**STAFF REPORT**  
**(One-Step Final Plat)**

**CASE NUMBER:** S/D 99-50 - BALTHROP 3<sup>RD</sup> ADDITION

**LOCATION:** Northeast corner of Central and Greenwich

(One-Step Final Plat Deferred from 7/22/99)

**VICINITY MAP**

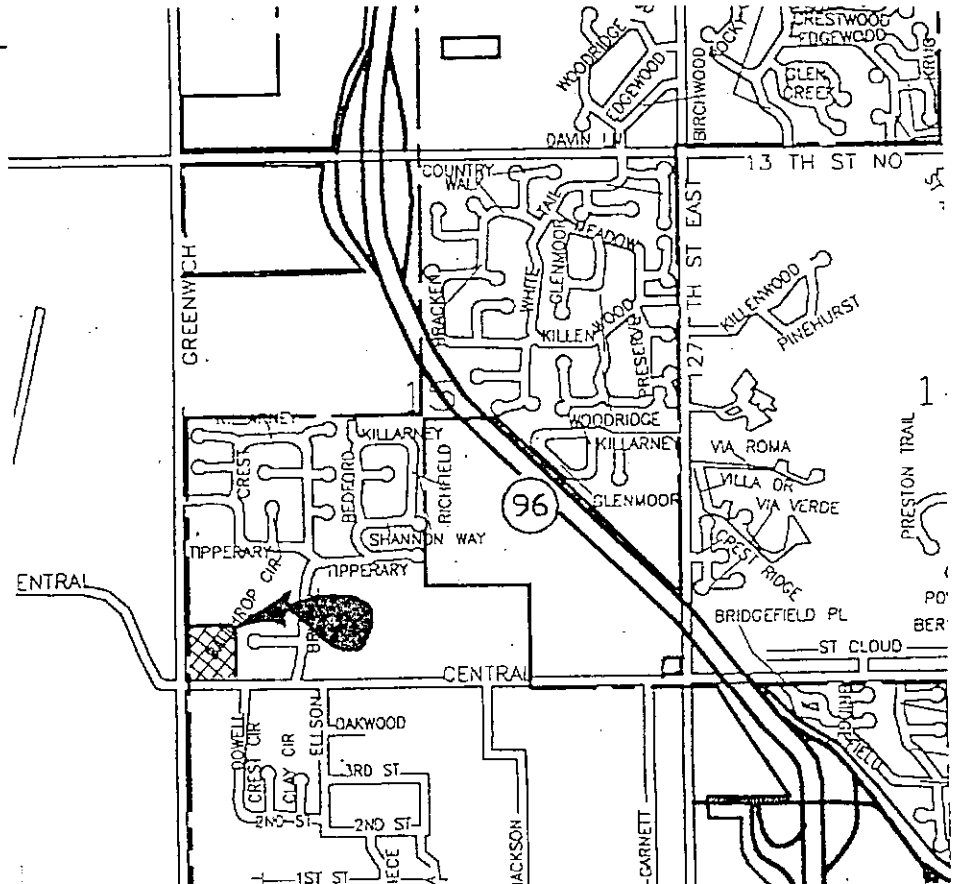
*sws ext. at site development  
cross lot & off-drainage  
agreements are required.*
